Project	IEEE 802.16 Broadband Wireless Access Working Group < http://ieee802.org/16 >
---------	---

Title	Correcting Flow Direction in Figure 482
-------	--

Re:	P80216g_D2.pdf
-----	----------------

Figure 482—Context transfer primitives initiated by a target BS

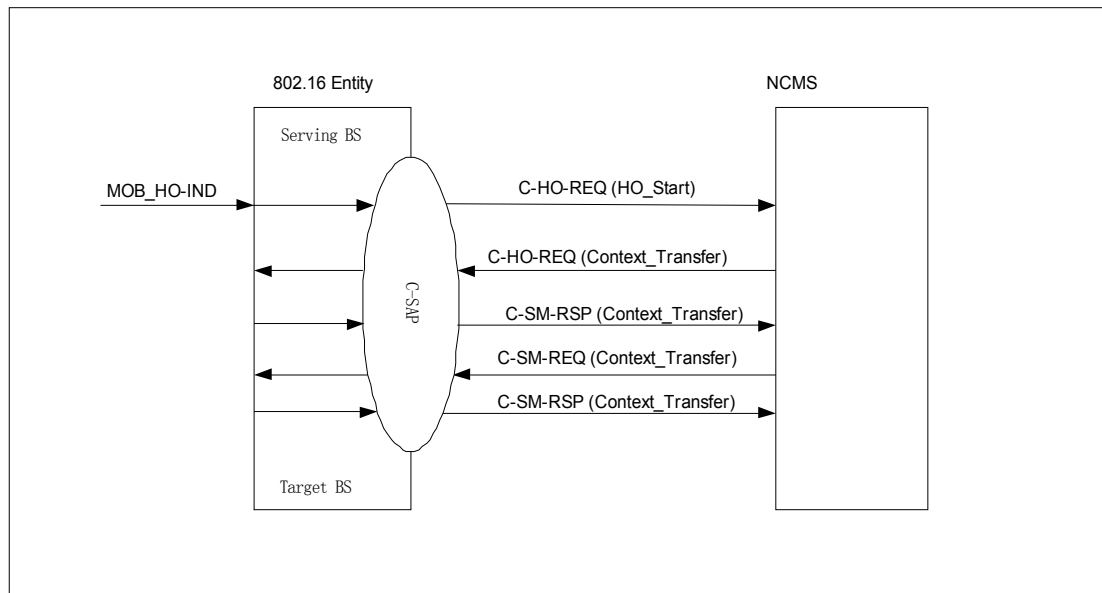
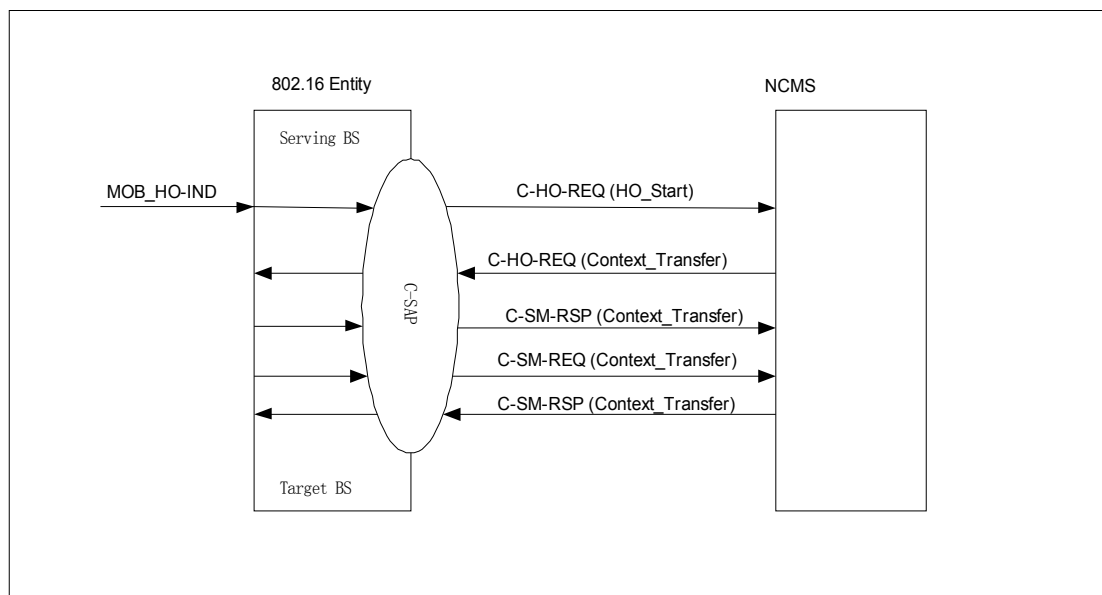
Abstract	This contribution corrects the direction of the last two flows in Figure 482. The Context Transfer request is originated from the target BS, not the source BS.
----------	---

[Change Figure 482 as follows]
